**TOWN OF NISKAYUNA
Conservation Advisory Council**

March 1, 2023

TOWN OF NISKAYUNA
CONSERVATION ADVISORY COUNCIL
Meeting Minutes
February 1, 2023

ITEM TITLE: EAF 2023-04: 2635 Balltown Rd. – Trinity Baptist Church -- site plan approval for clearing and construction of recreational fields.

START DATE:	
STAMP:	
DATE: 01/27/2023	
FILE:	
PAGE CONTENT:	
SITE PLAN, NOTES LOCATION MAP, LEGEND	
DRAFTER: PJB	ENGINEER: CLIFTON VANGUILDER
PAPER SIZE: 22X34	SCALE: AS NOTED
SHEET: 1 OF 1

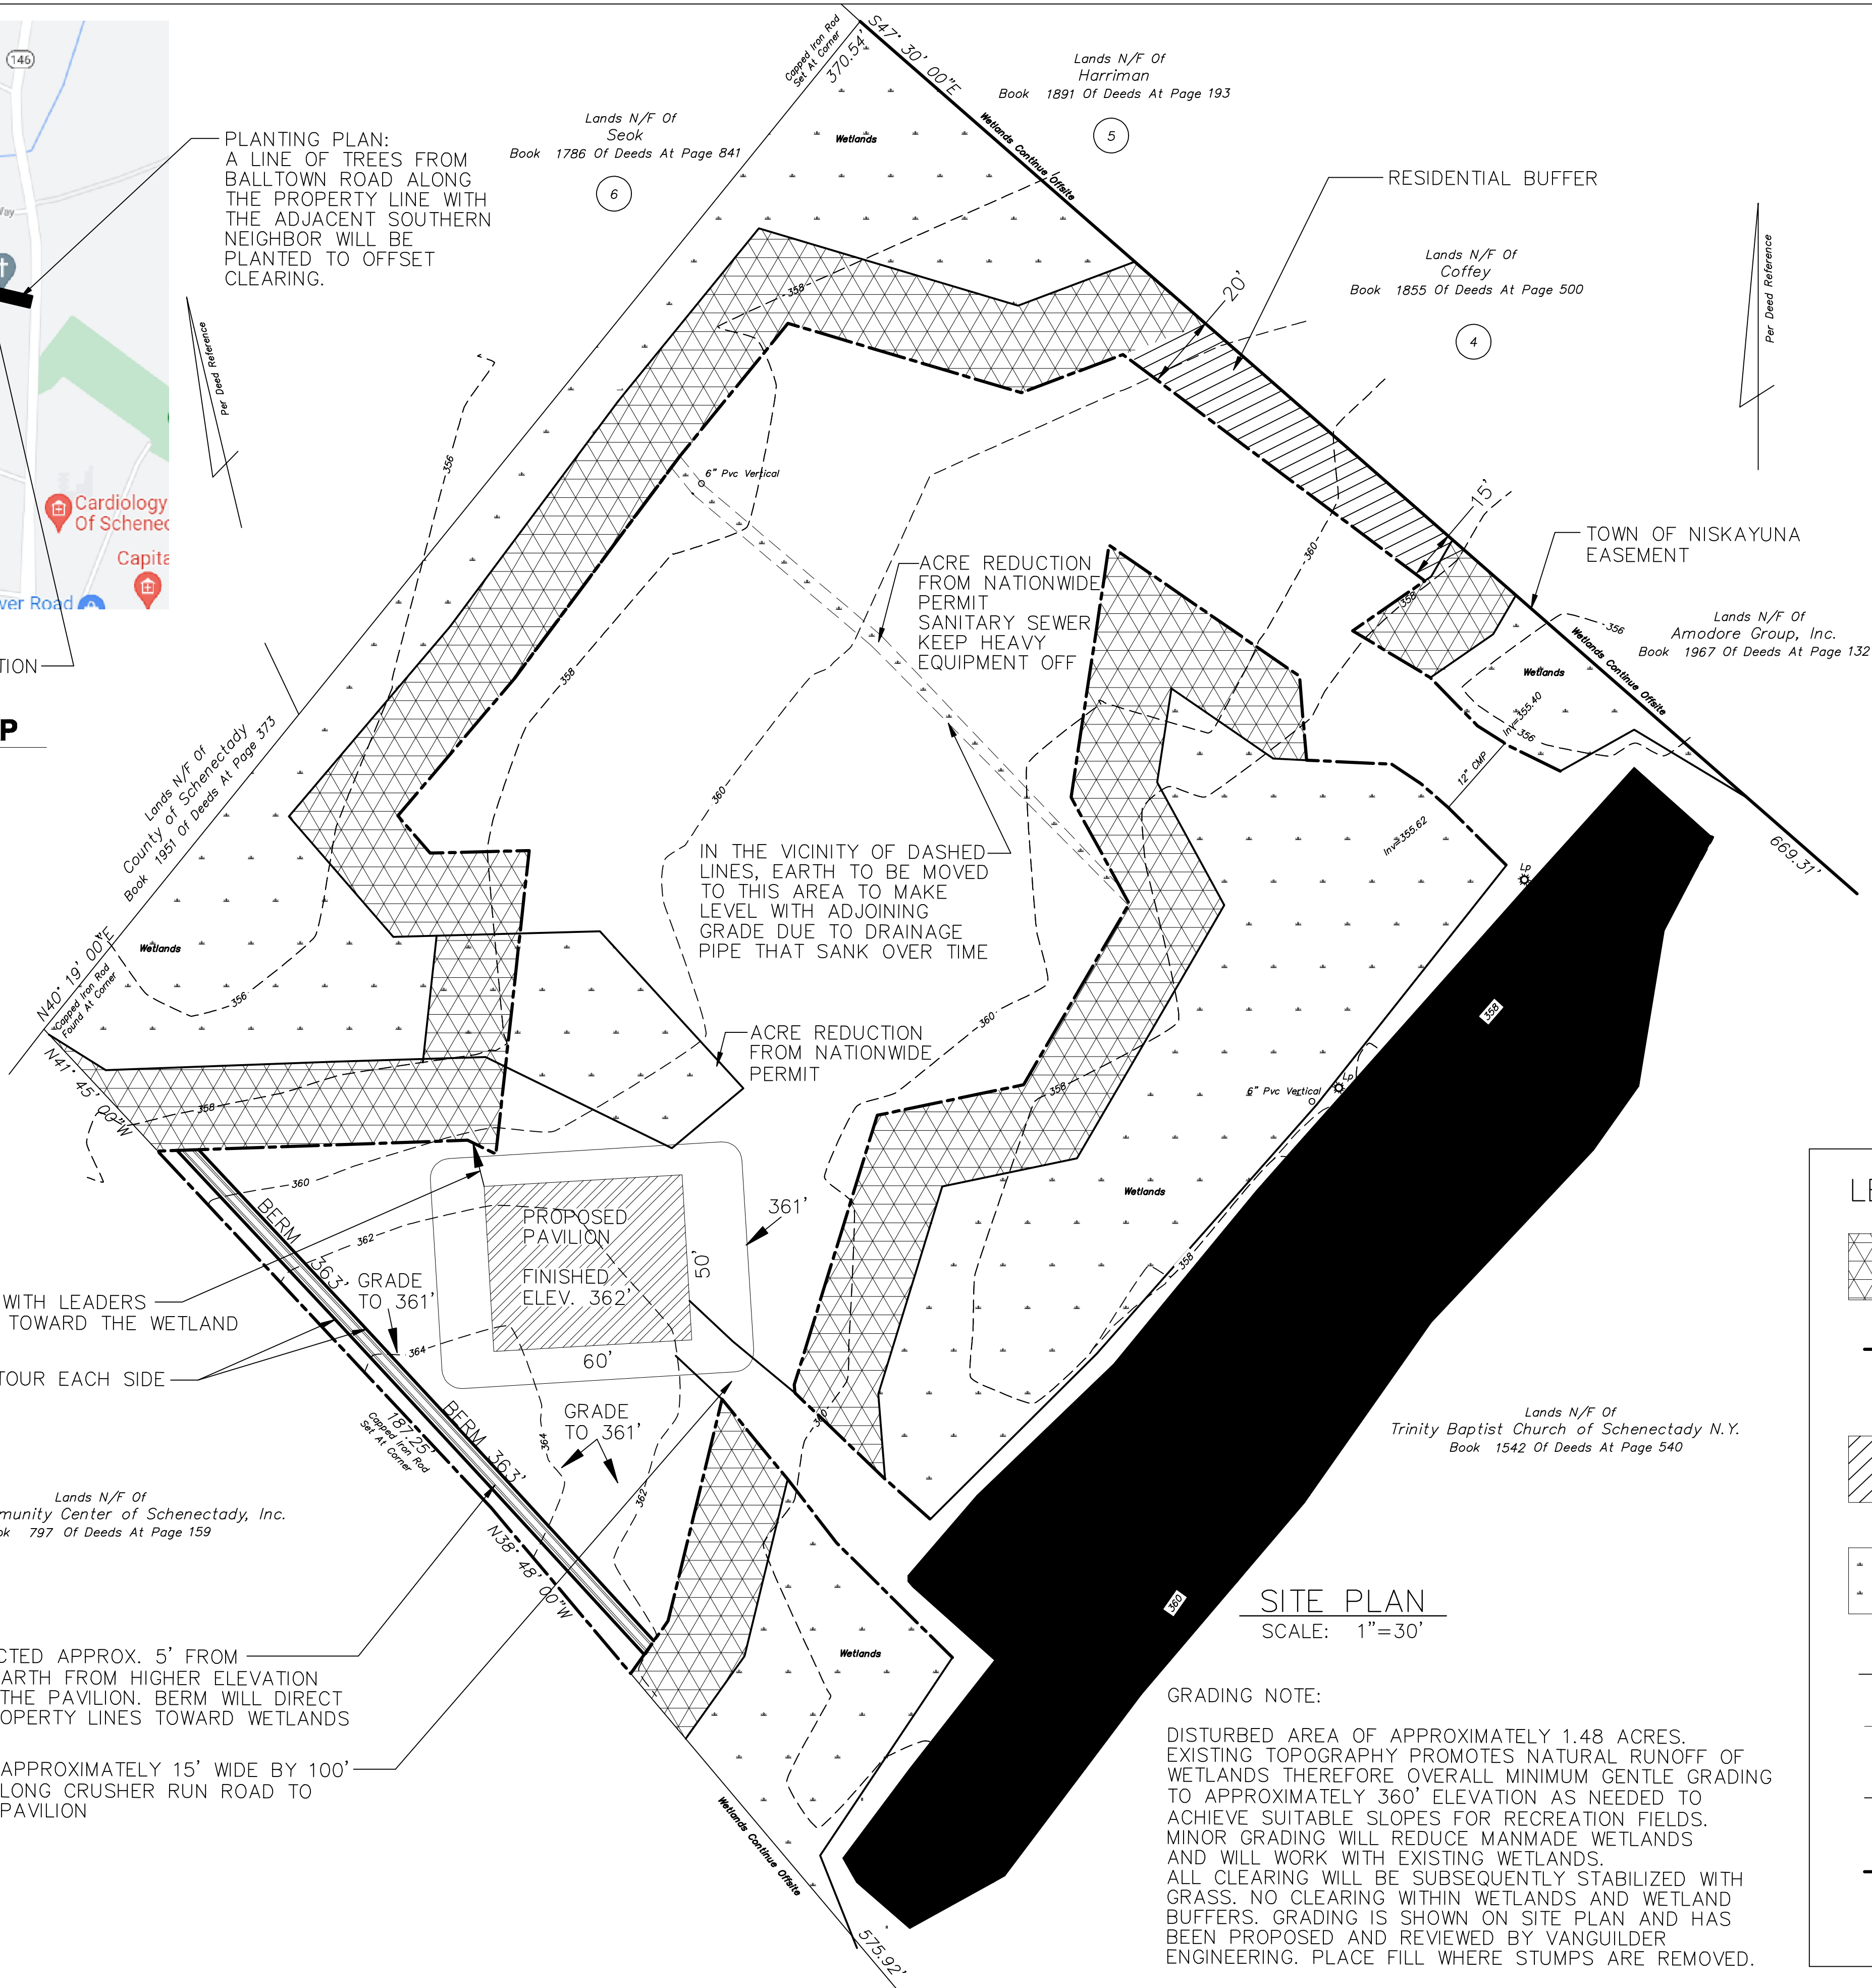
1. Applicant – update the site plan drawing to include
 - a. Add wetland symbol to the 1/10th of an acre area ☒
 - b. Add wetland symbol to the land along the broken pipe ☒
 - c. Add limits of clearing to the site plan ☒
 - d. Determine and label the square footage of land being cleared ☒
 - e. Determine if a grading plan is needed – provide if needed
 - f. Identify approximate location of trees to be removed on the drawing and show where trees will be added to offset or partially offset ☒
 - g. Determine and label where fill soil will be needed. ☒
2. Planning Office
 - a. Organize a site walk with PB and Tree Council ☒
 - b. Research potential easement near the broken pipe ☒

10/3/22 Planning Board (PB) meeting – Mr. Noyes attended the meeting and presented the Rev 8/15/22 site plan drawing to the Board. He stepped through the open action items and a general review of the project status ensued. During the course of the discussion the PB requested the following.

- a. Add grading lines in the vicinity of the berm – *a 362' contour on either side of the berm note has been added*
- b. Add the requirement of a fence at the 25' wetland buffer – *a split rail fence along the wetland buffer has **NOT** been added to the plan set*

- c. Add a note that the 3 large oak & 7 or 8 large white pine trees will be preserved –
see below

In addition to a note about the split rail fence and updating the tree clearing language - the only other thing remaining for the previous checklists appears to be that the applicant has not submitted a planting plan to offset the tree clearing. This was originally discussed with the Tree Council as a line of trees from Balltown Road along the property line with the adjacent southern neighbor. This can be included as a condition in the proposed resolution.

1/9/23 Planning Board (PB) meeting – The applicant appeared at the PB meeting and presented the revised site plan drawing. The split rail fence located at the 25' buffer from all wetlands had been added. The Planning Office noted the additional information that the Tree Council requested be placed on the drawing had not been included. After a short discussion the applicant agreed to revise the drawing and include the additional information.

Mr. Noyes provided the Planning Office with an updated revision of the site plan drawing dated 8/15/22. Many of the action items listed above were addressed and are identified with a ☒. Identifying which trees will be removed and where replacement trees will be added on the site remains an open item.

An updated site plan drawing was provided that includes the information the Tree Council requested. The last step for the project is to have the CAC review the EAF form and make a SEQR declaration. The CAC should be prepared to review and make a recommendation to the Planning Board on SEQR at this meeting.

- PLANTING PLAN:
A LINE OF TREES FROM
BALLTOWN ROAD ALONG
THE PROPERTY LINE WITH
THE ADJACENT SOUTHERN
NEIGHBOR WILL BE
PLANTED TO OFFSET
CLEARING.

3. LARGE OAKS IN THE VICINITY OF THE PAVILION AND 7 TO 8 LARGE WHITE PINES NOTED WITHIN THE LIMITS OF CLEARING SHALL BE RETAINED AND PROTECTED DURING AND AFTER CONSTRUCTION AND GRADING. ADDITIONALLY, DEVELOPER SHALL MARK TREES TO BE PRESERVED WITH FLAGGING AND SAFEGUARD THEM BY SUCH HIGH VISIBILITY BARRIERS OR OTHER PROTECTIVE MEASURES AS SHALL EFFECTIVELY PREVENT INJURY TO THE TREE AND ITS ROOT SYSTEM DURING CONSTRUCTION, DUE TO SUCH CAUSES AS SOIL COMPACTION, GRADE CHANGE, ROOT SEVERANCE, DRAINAGE CHANGE, SOIL CHEMISTRY CHANGE AND TRUNK AND LIMB IMPACT CHANGE. THE DEVELOPER SHALL PROVIDE, THAT TREES TO BE PRESERVED ARE INSPECTED FOR TREE CONDITION AND TREE PROTECTION ADEQUACY AT FOUR STAGES, AS APPLICABLE, IN THE COURSE OF DEVELOPMENT: PRIOR TO SITE DISTURBANCE, PRIOR TO SUBDIVISION PLOT PLAN FINAL APPROVAL, PRIOR TO THE ISSUANCE OF A BUILDING PERMIT AND PRIOR TO CERTIFICATE OF OCCUPANCY ISSUANCE. THE INSPECTION SHALL BE CONDUCTED BY A MEMBER OF THE AMERICAN SOCIETY OF CONSULTING ARBORISTS OR BY QUALIFIED PROFESSIONAL TRAINED AND EXPERIENCED IN TREE PRESERVATION AS APPROVED BY THE TREE COUNCIL. THE INSPECTOR SHALL PROVIDE DIRECTLY TO THE TOWN ENFORCEMENT OFFICER A COPY OF THE INSPECTION REPORT. THE REPORT SHALL CONTAIN SUCH INFORMATION AS DETERMINED BY THE TREE COUNCIL AS SUFFICIENT TO EVALUATE THE CONDITION OF TREES DESIGNATED FOR PRESERVATION AND SHALL BE CERTIFIED AS TRUE AND ACCURATE BY THE INSPECTOR. NO APPROPRIATION OR AUTHORIZATION FOR ACTION SHALL OCCUR UNTIL THE TOWN ENFORCEMENT OFFICER CERTIFIES THAT THE INSPECTION REPORT IS SATISFACTORY. PRIOR TO CONTINUED DEVELOPMENT OR THE ISSUANCE OF A CERTIFICATE OF OCCUPANCY, THE DEVELOPER SHALL PROVIDE TO THE TOWN MONEYS EQUAL TO THE VALUE OF ANY TREE DESIGNATED FOR PRESERVATION THAT IS REMOVED OR INJURED OR THAT DIED AS A RESULT OF CONSTRUCTION.

A LINE OF TREES FROM BALLTOWN ROAD ALONG THE PROPERTY LINE WITH THE ADJACENT SOUTHERN NEIGHBOR WILL BE PLANTED TO OFFSET CLEARING. SEE LOCATION MAP AS THIS AREA IS NOT SHOWN ON SITE PLAN.

DATE: DECEMBER 6, 2022 SCALE: 1" = 50' DWG. 5429A-S4 AVG SHEET 1 OF 2

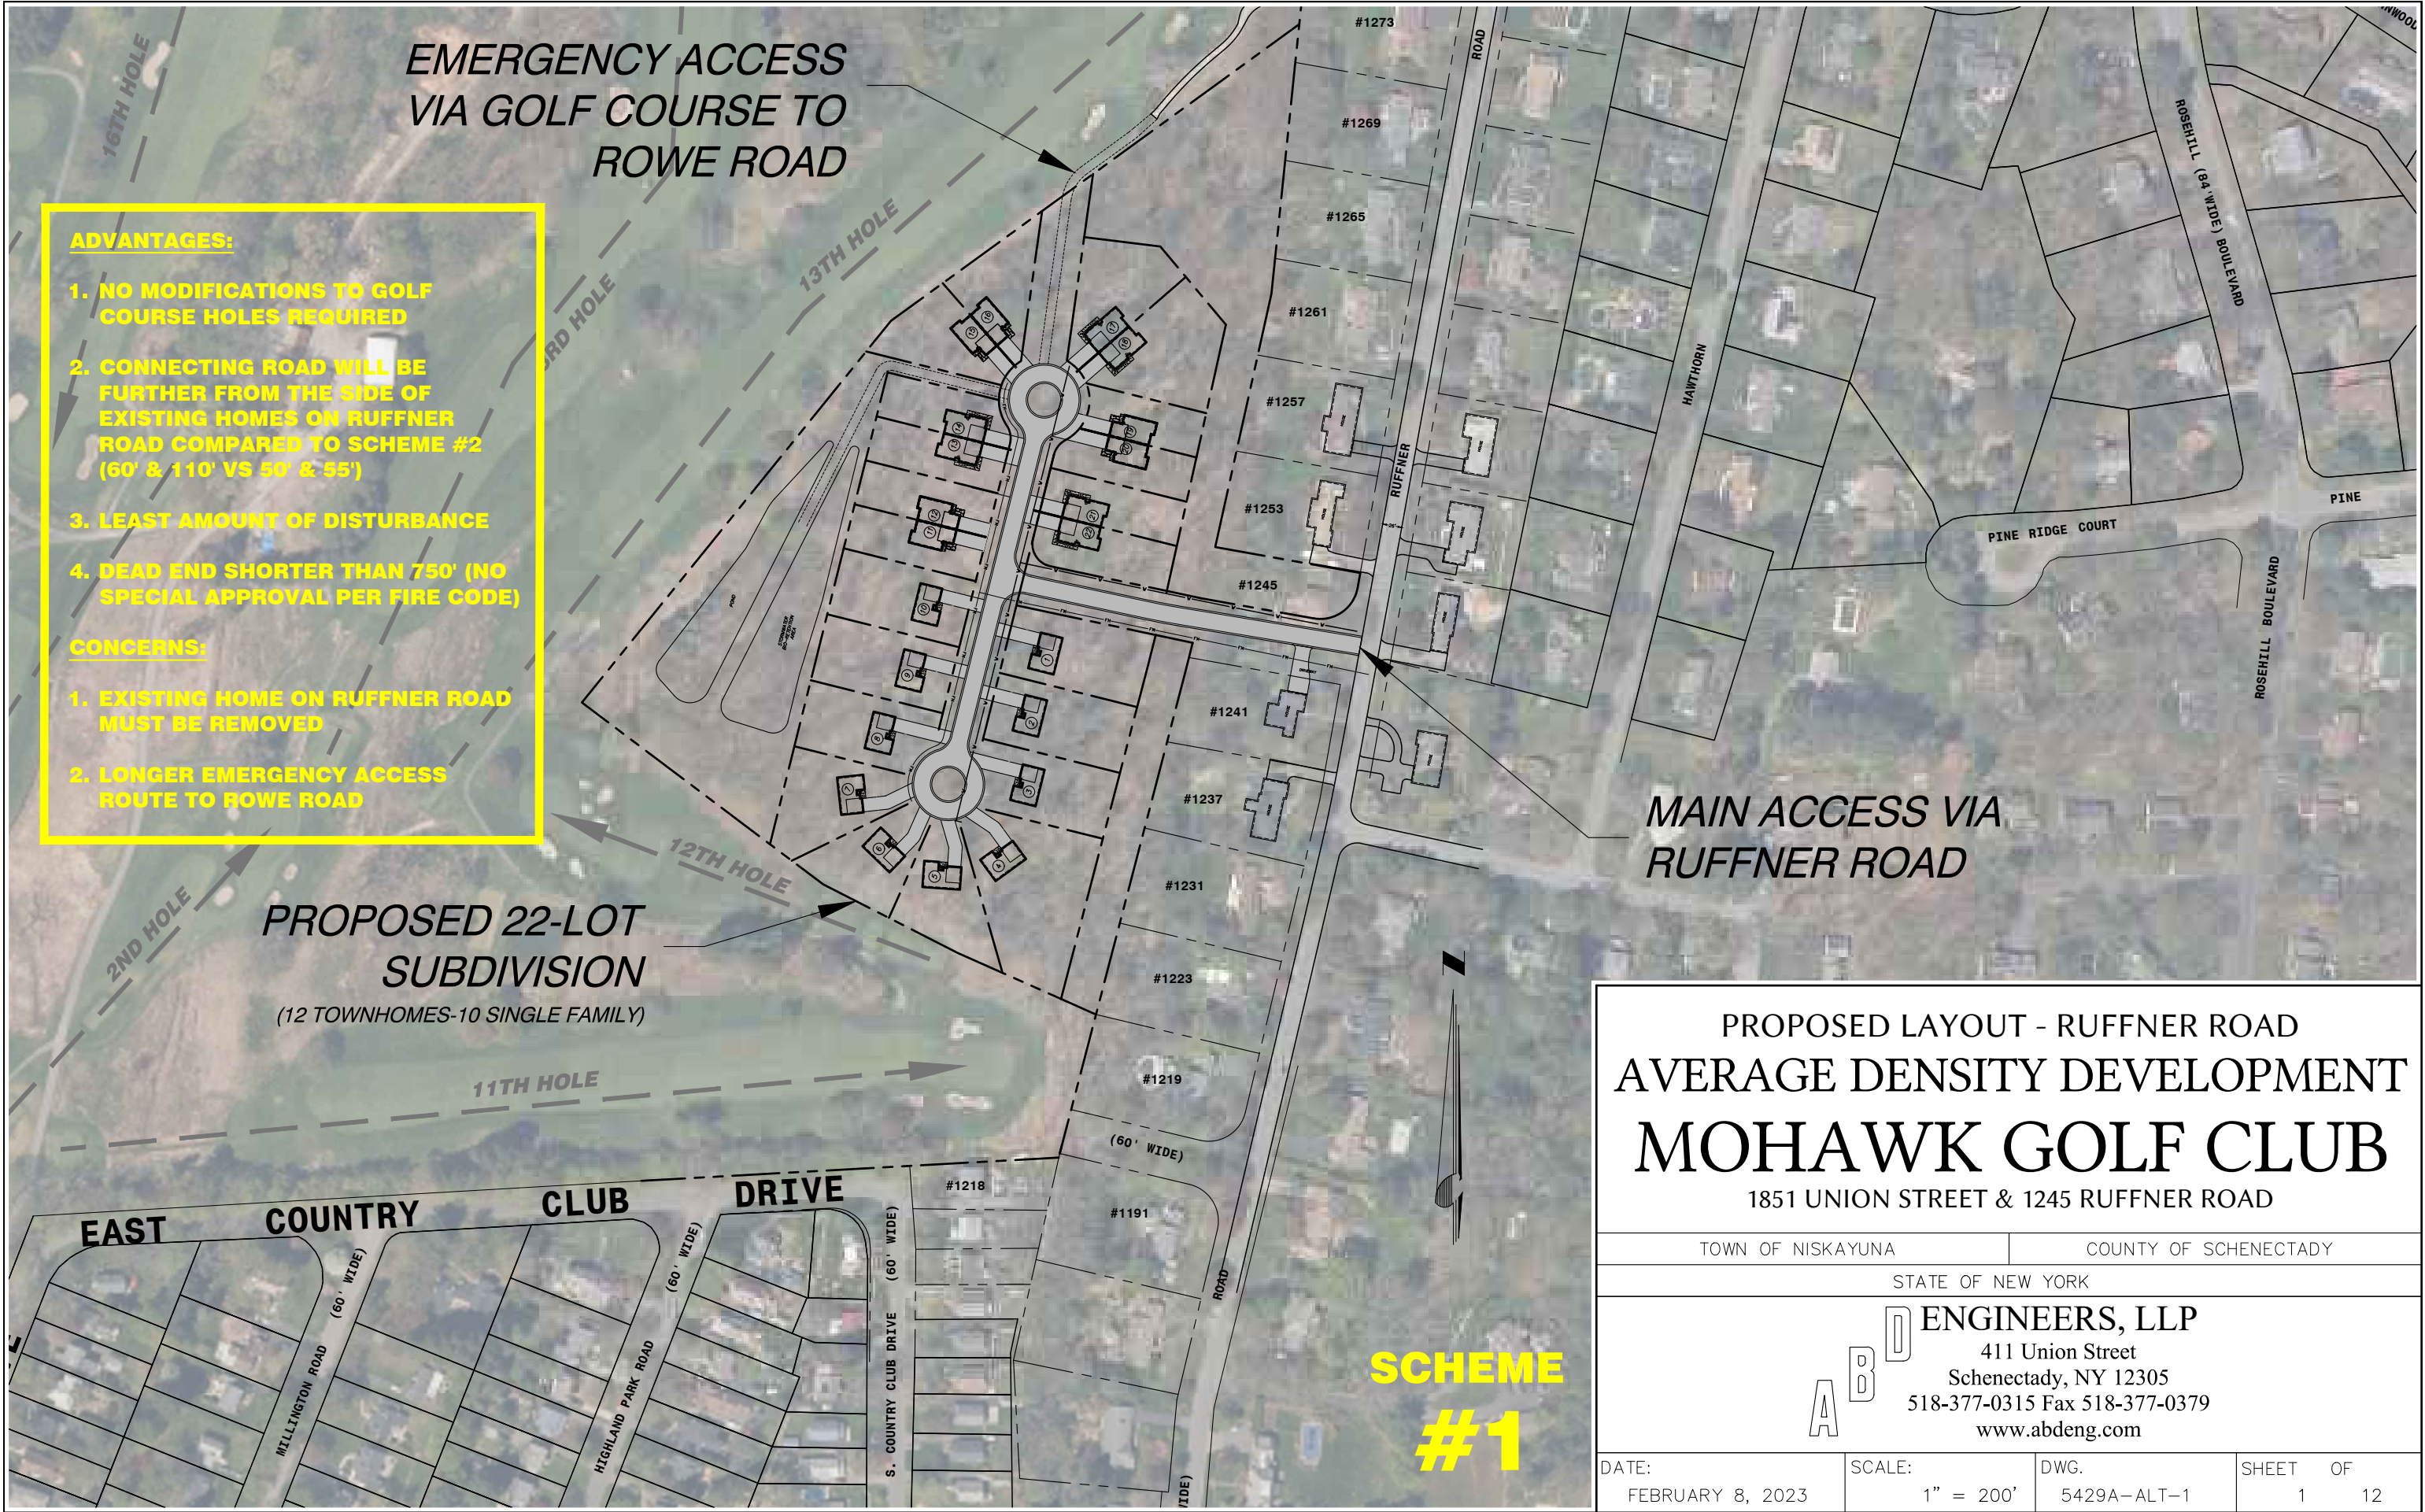
1. Explore and present alternate site plan layouts that eliminate the need for cul-de-sacs. This may include ring roads or a road looping through the property.

11/15/22 Conservation Advisory Council (CAC) meeting – Dave Kimmer and Bill Sweet repeated the presentation they made to the PB on 11/14/22. During the discussion Mr. Sweet added that the Mohawk Club would maintain the storm water management areas. The CAC was concerned with the loss of greenspace with the proposal and asked for greenspace to be offset somewhere else on the Club parcel. The developer did not want to offset greenspace within the Mohawk Golf Club. The CAC requested the developer maximize the undevelopable greenspace within the subdivision by reducing some of the oversize lots at the ends and adding this area to the community greenspace. The CAC agreed with the additional detail the PB requested and added that they would like the developer to explore quantifying and mitigating the increased traffic on Ruffner Road and the surrounding area.

1. A secondary access to the subdivision is now shown in the plans. A 12' wide grass paver access road will connect to the existing golf course maintenance / cart path via a full width 60' Town R.O.W. stub off of the northern cul-de-sac.
2. There are two "Sheet 1s" included in the plan set. The second Sheet 1 demonstrates that it is possible, although less desirable, to meet the open space requirements for an ADD project set forth in Niskayuna zoning code Section 220-28 F (4) (a).
3. A separate color exhibit is included which demonstrates why building roads from either of the existing access points to the north or south along Ruffner Road would not be possible without steep slopes or excessive disturbance to existing golf course features and / or neighboring properties.
